World Forum for Harmonization of Vehicle Regulations

Working Party on Lighting and Light-Signalling

Simplification of UN Regulations Nos. 48, 53, 74 and 86

Proposal for a new supplement to the 03, 04 and 05 series of amendments to UN Regulation No. 48

Paragraph 6.22.9.1., amend to read:

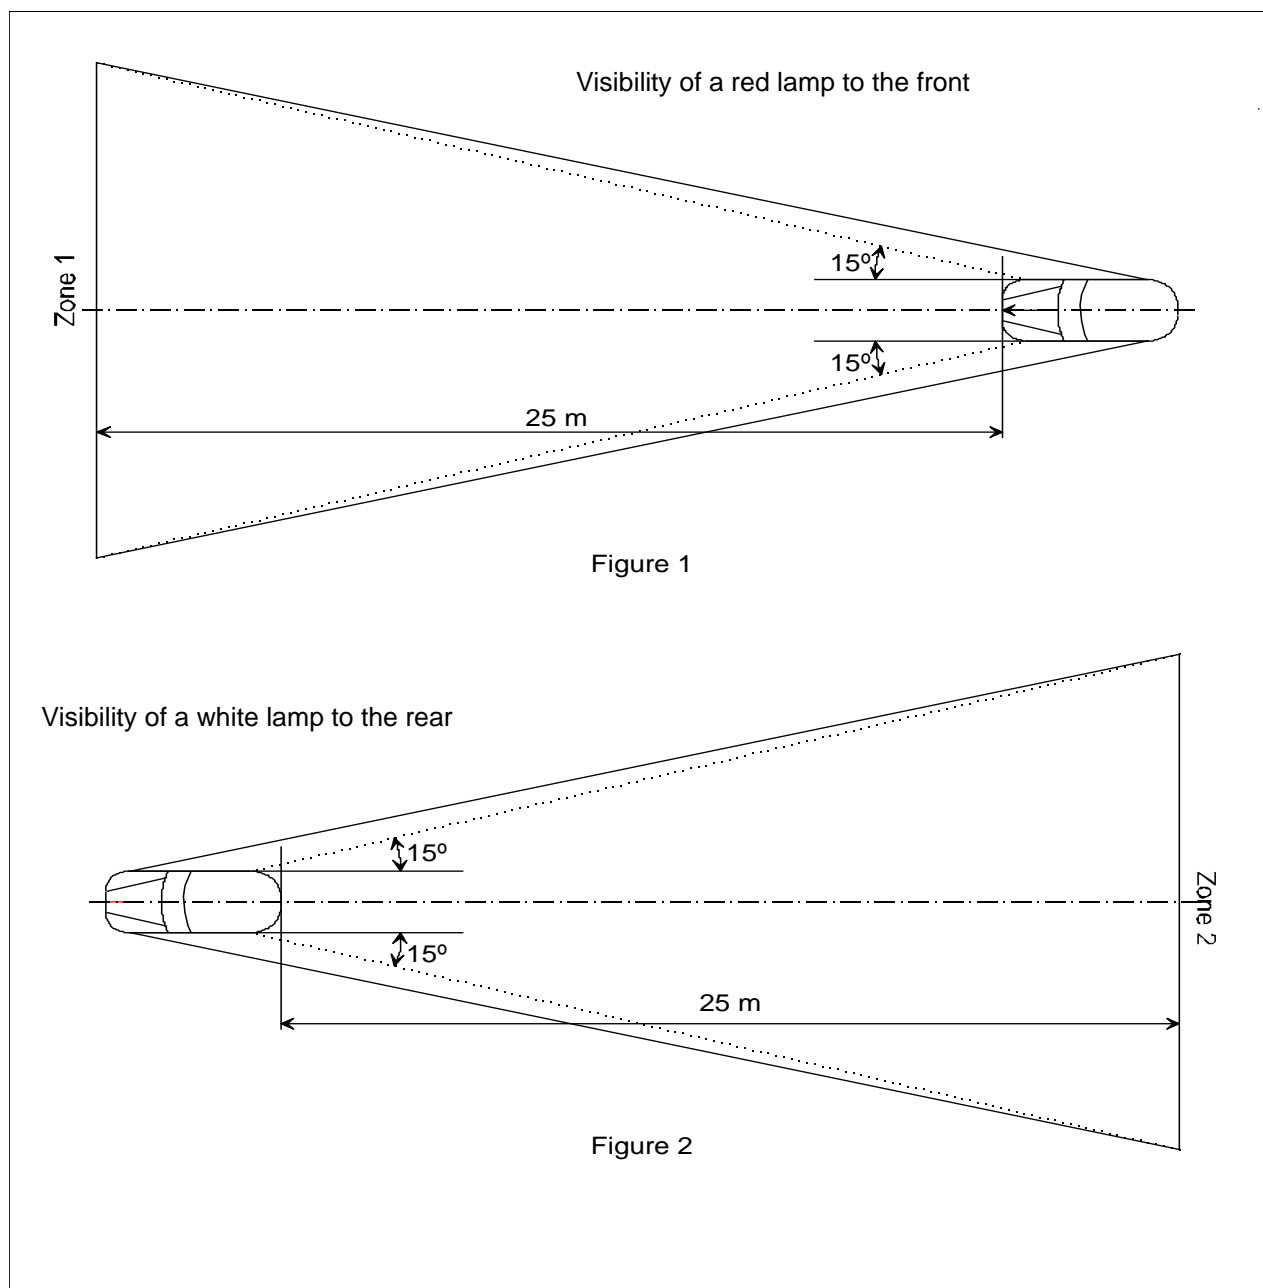
"6.22.9.1. An AFS shall be permitted only in conjunction with the installation of headlamp cleaning device(s) according to Regulation No. 45²² for at least those lighting units, which are indicated under item ~~9.2.3.~~ of the communication form conforming to the model in Annex 1 to Regulation No. 123 or under item ~~9.3.2.3.~~ **9.3.3.** in Annex 1 to Regulation No. [RID] 149, if the total objective luminous flux of the light sources of these units exceeds 2,000 lm per side, and which..."

Paragraph 6.22.9.1., amend to read:

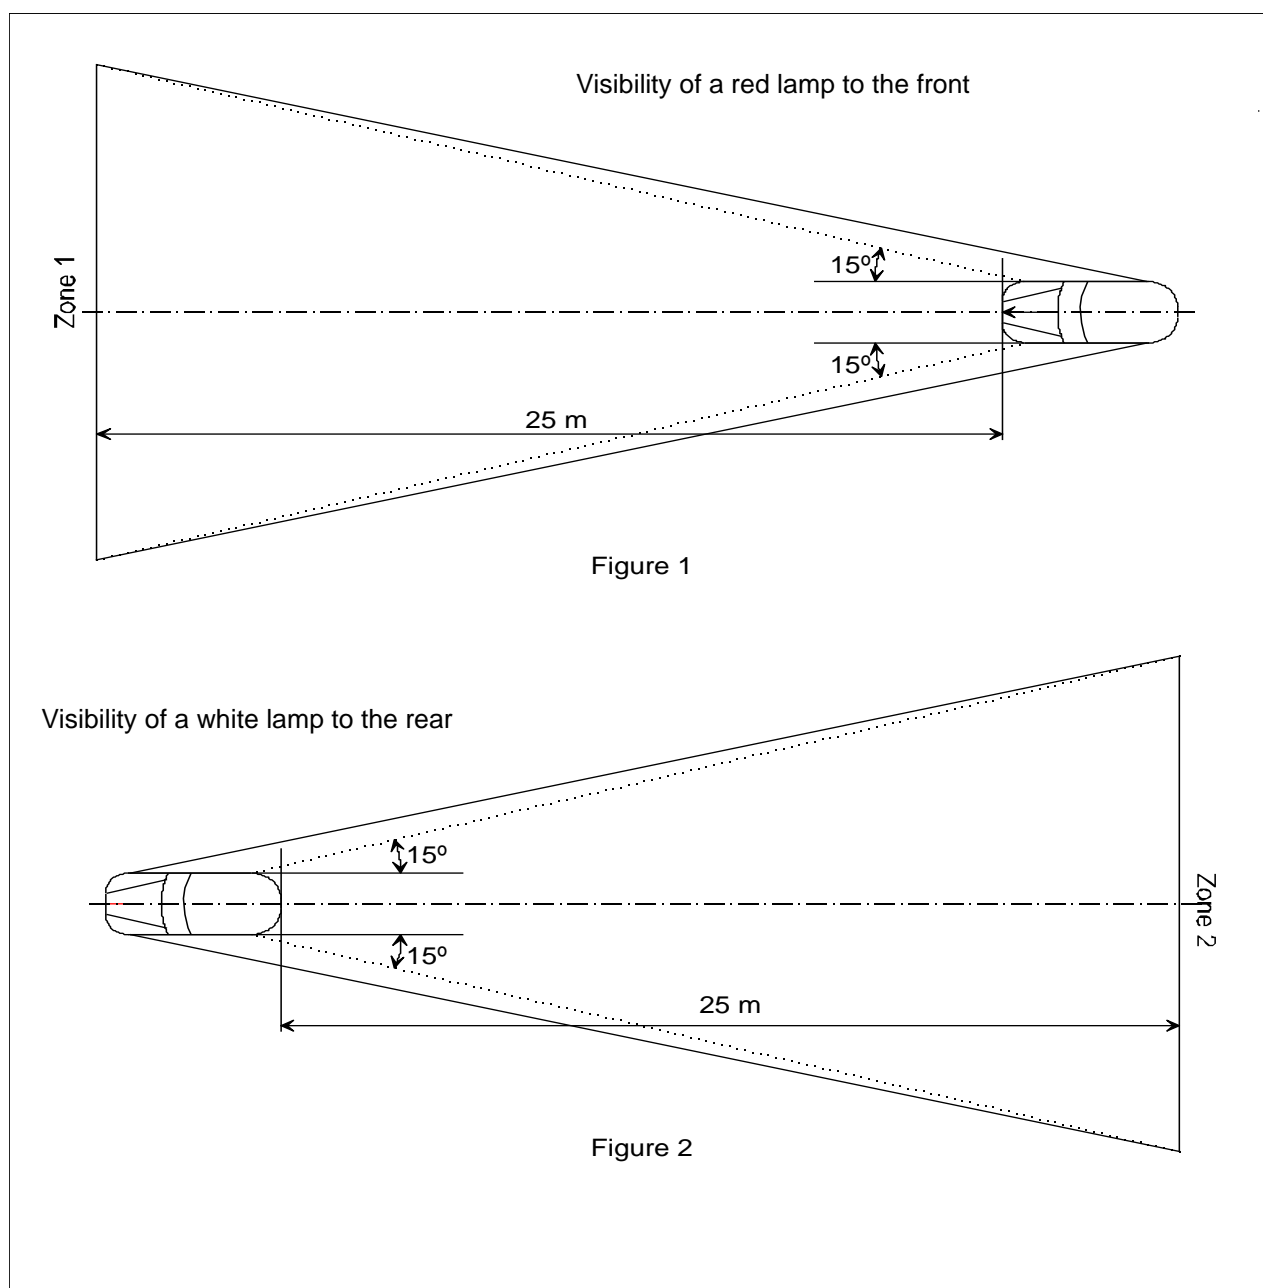
“6.22.9.1. An AFS shall be permitted only in conjunction with the installation of headlamp cleaning device(s) according to Regulation No. 45¹⁹ for at least those lighting units, which are indicated under item ~~9.2.3.~~ of the communication form conforming to the model in Annex 1 to Regulation No. 123 or under item ~~9.3.2.3.~~ **9.3.3.** in Annex 1 to Regulation No. [RID] 149, if the total objective luminous flux of the light sources of these units exceeds 2,000 lm per side, and which...”

Paragraph 6.22.9.1., amend to read:

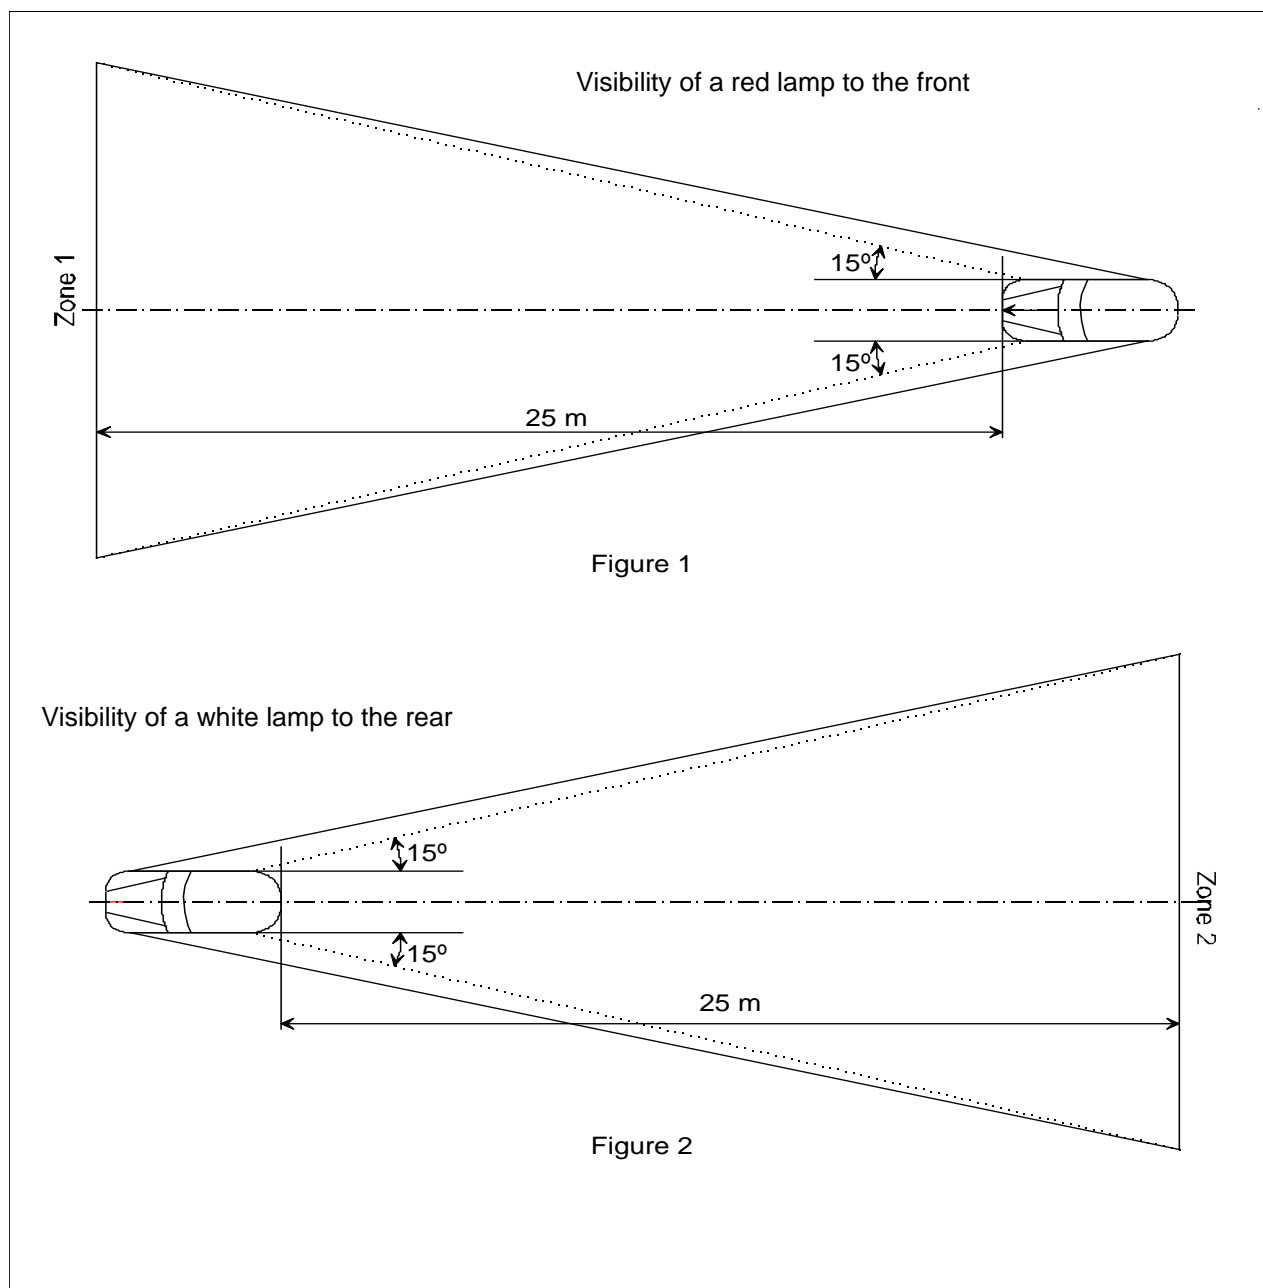
"6.22.9.1. An AFS shall be permitted only in conjunction with the installation of headlamp cleaning device(s) according to Regulation No. 45¹⁹ for at least those lighting units, which are indicated under item ~~9.2.3.~~ of the communication form conforming to the model in Annex 1 to Regulation No. 123 or under item ~~9.3.2.3.~~ **9.3.3.** in Annex 1 to Regulation No. [RID] 149, if the total objective luminous flux of the light sources of these units exceeds 2,000 lm per side, and which..."
